Application of Clark Property and Porch & Square to rezone from RSM (Small Lot Residential Mix) (conditional) to MR-2 (Medium Density Residential-2) at 1058 and 1078 Moreland Avenue.

PETITION NO: N1. Z-22-1245472 (2022-1731)

Z-22-1245472 (2022-1731)
Recommended Conditions
1058 & 1078 Moreland Avenue
(July 1, 2022)

STAFF ANALYSIS

CLARK PROPERTY R+D Skyhaven Quarry DEKALB SITE PLAN	
Project number	1078
Date	2022.04.27
Drawn by	J.WHITE
Checked by	J.K.AVERY
A00	
Scale	1" = 50'-0"

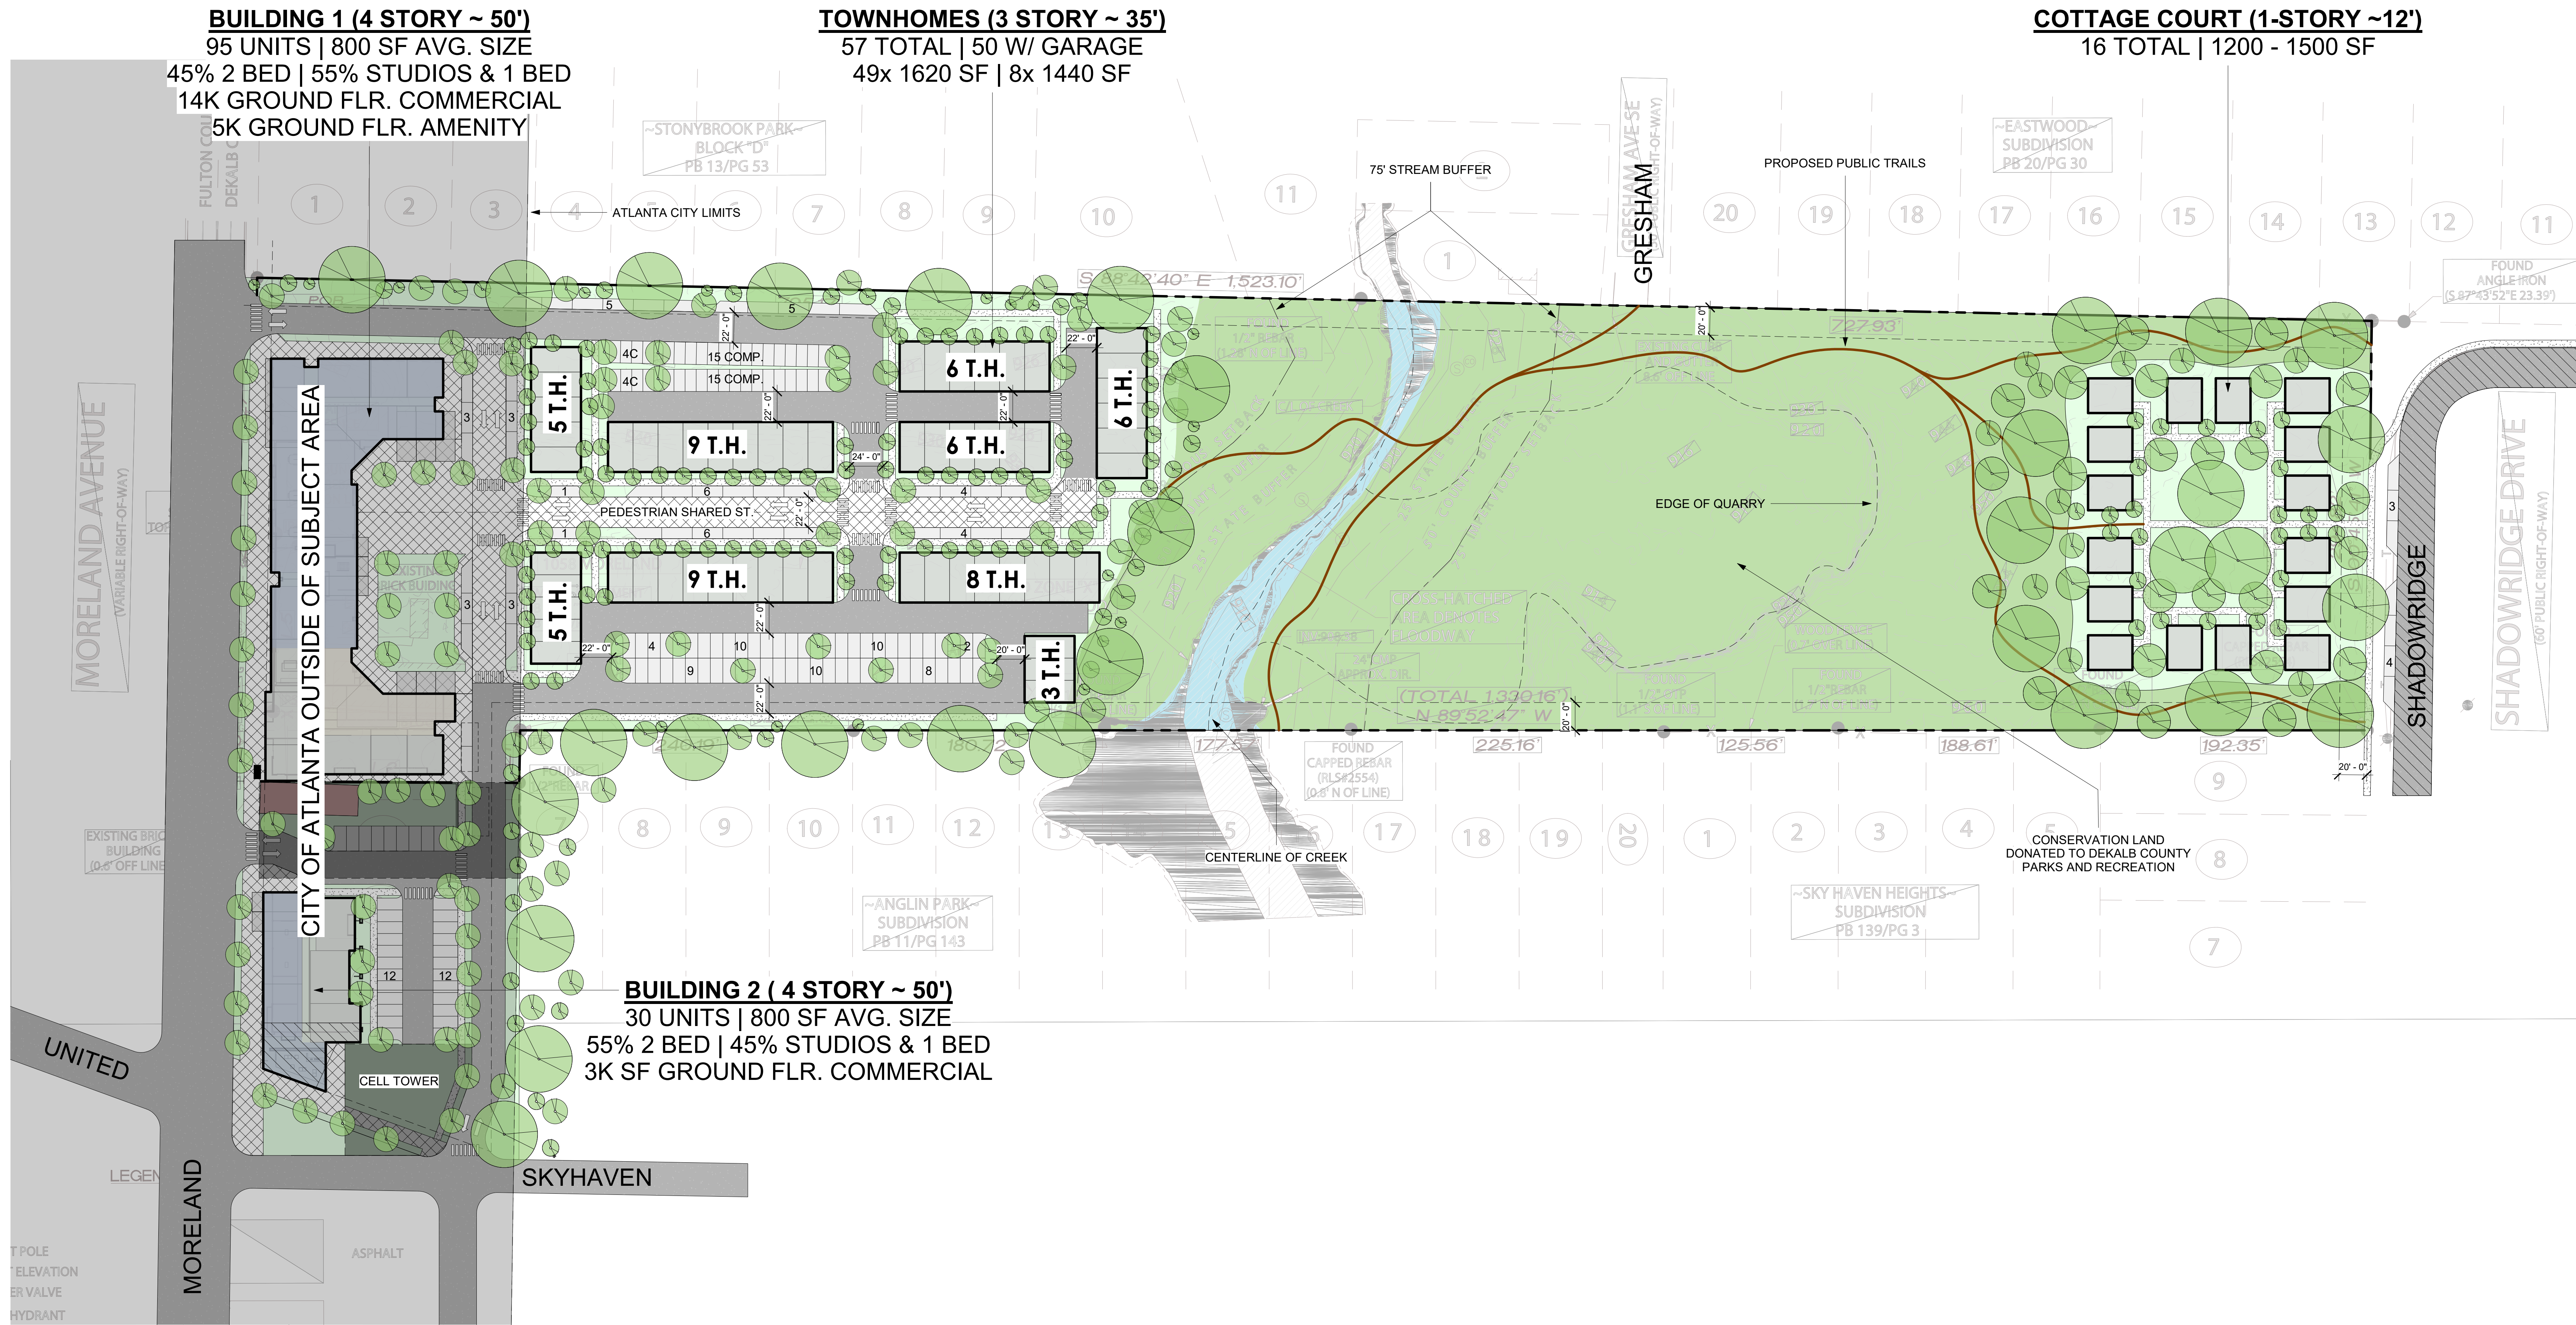
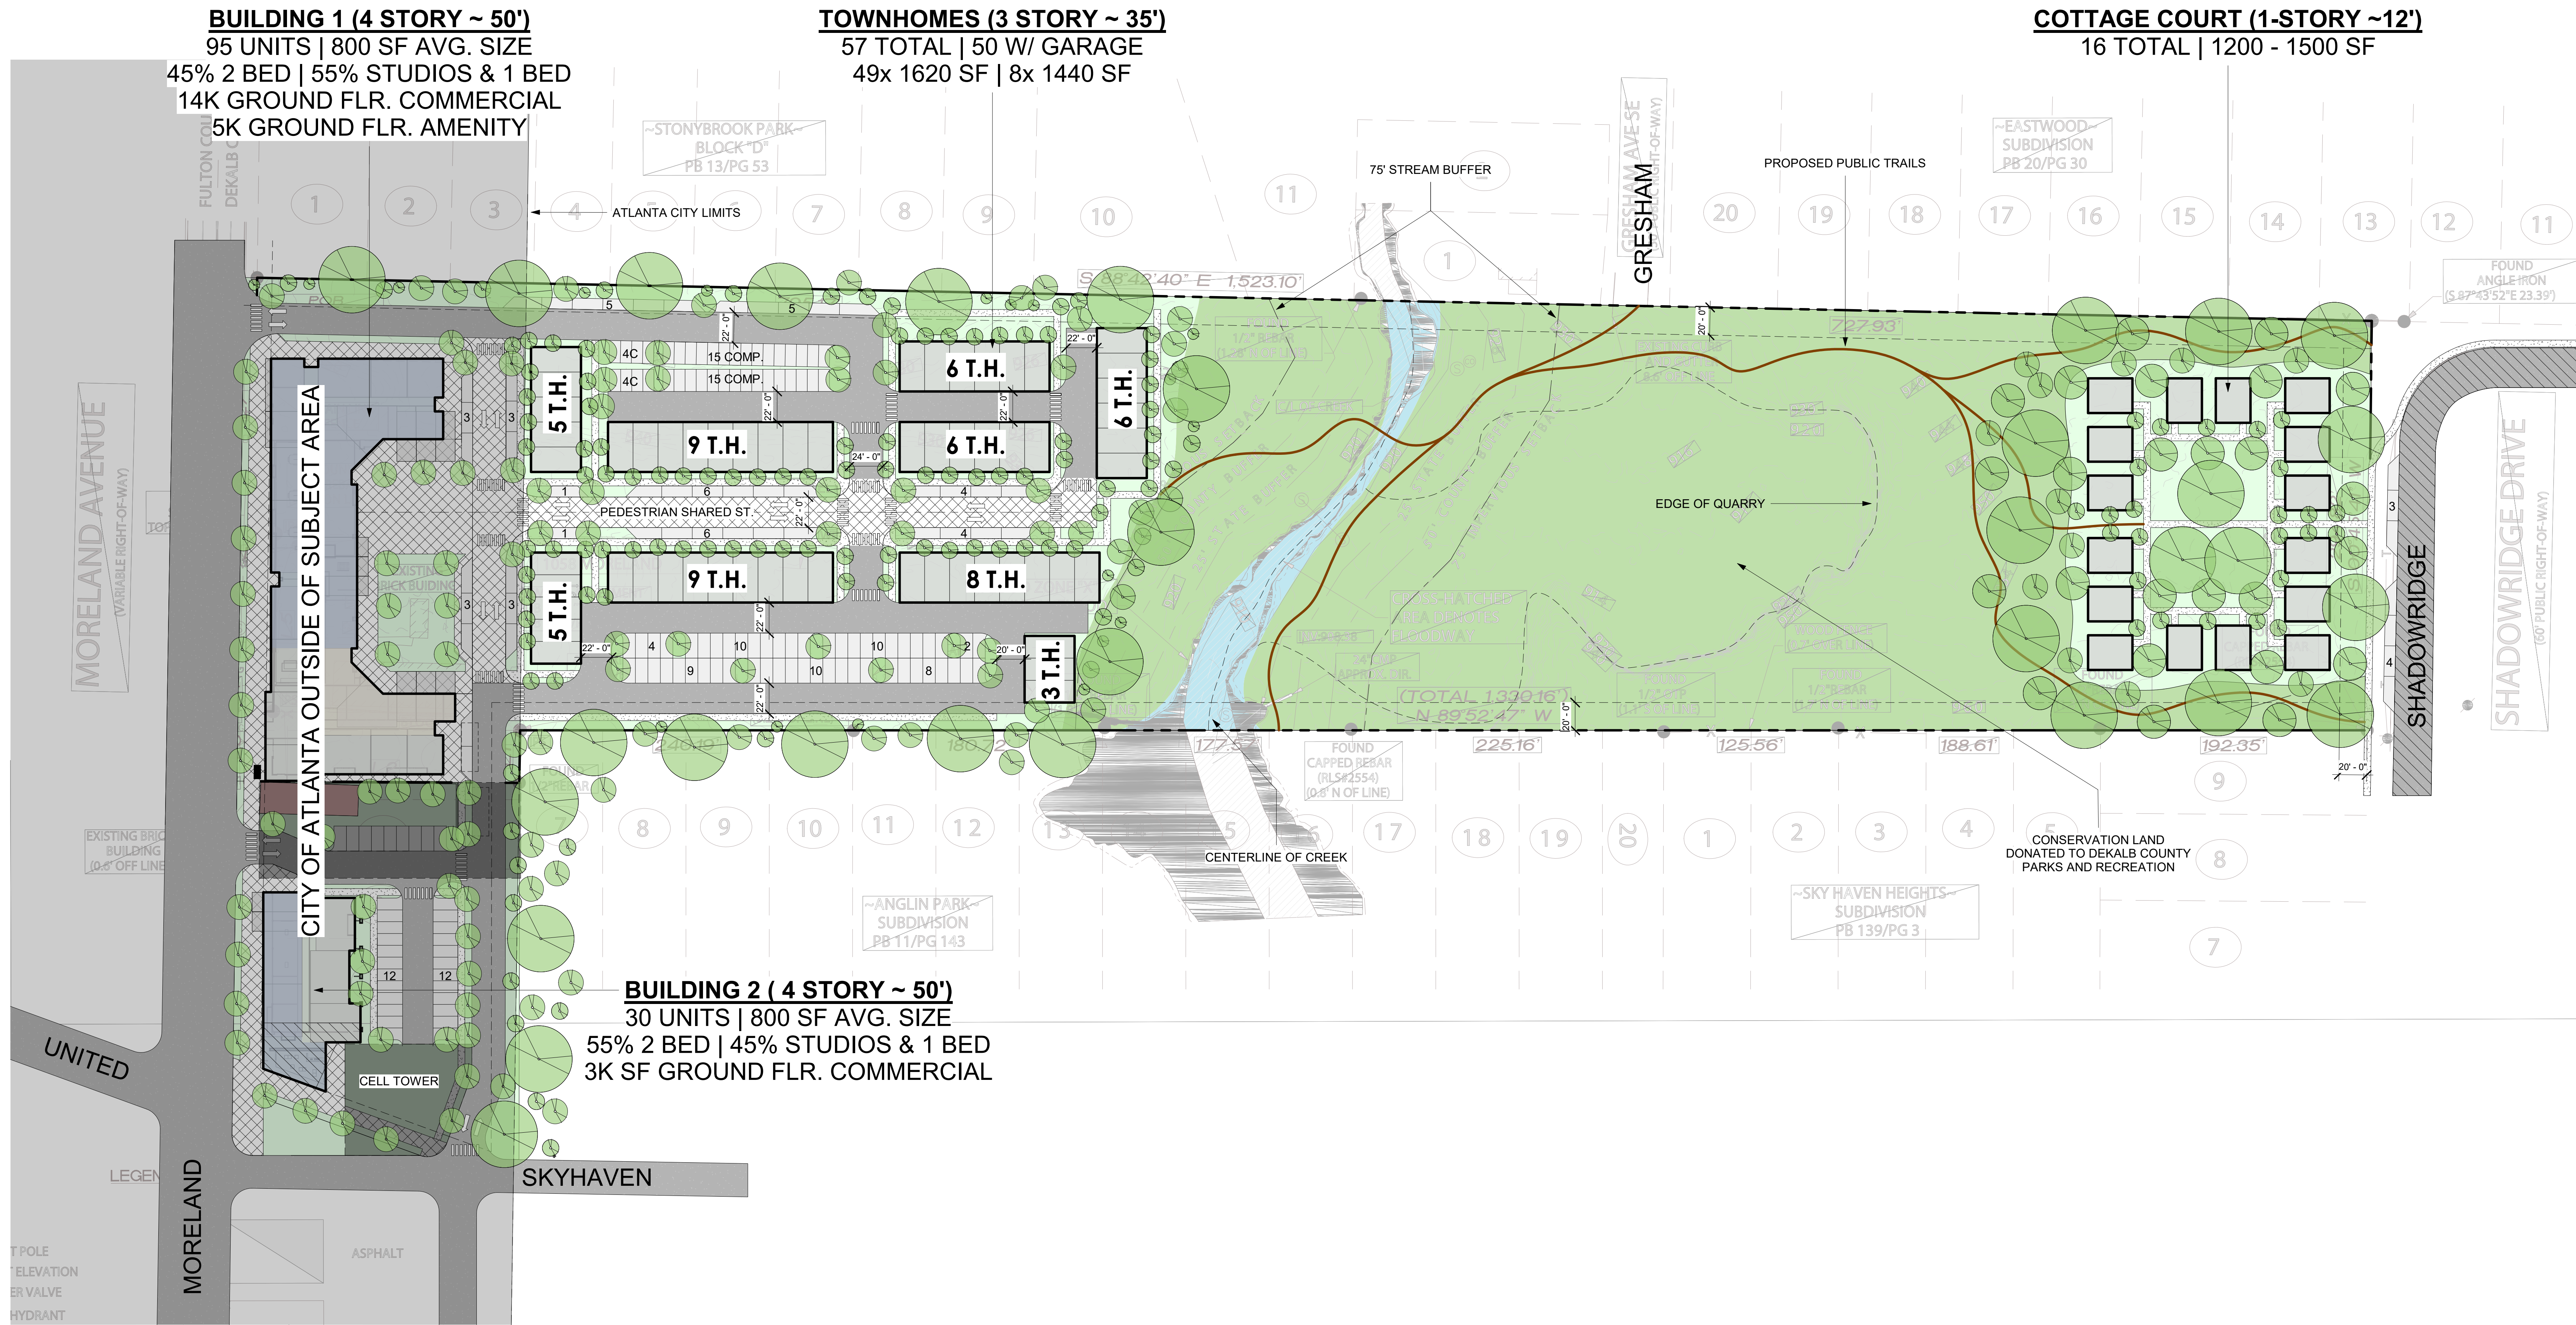
Conceptual plan doesn't indicate the location of the stormwater management facility. Concerns are related to the discharge point of the facility. Consideration must be given as to where the discharge pipe from the facility is directed as to not create adverse effects.

Runoff Reduction Volume shall be provided, unless technical justification is provided as to the unfeasibility. Strongly recommend to investigate the site and identify location where RRv can be provided and re-design/revise the layout to comply with the RRv requirement.

The conceptual drawing doesn't show or indicate the parking spaces/areas to serve the cottage part of the development.
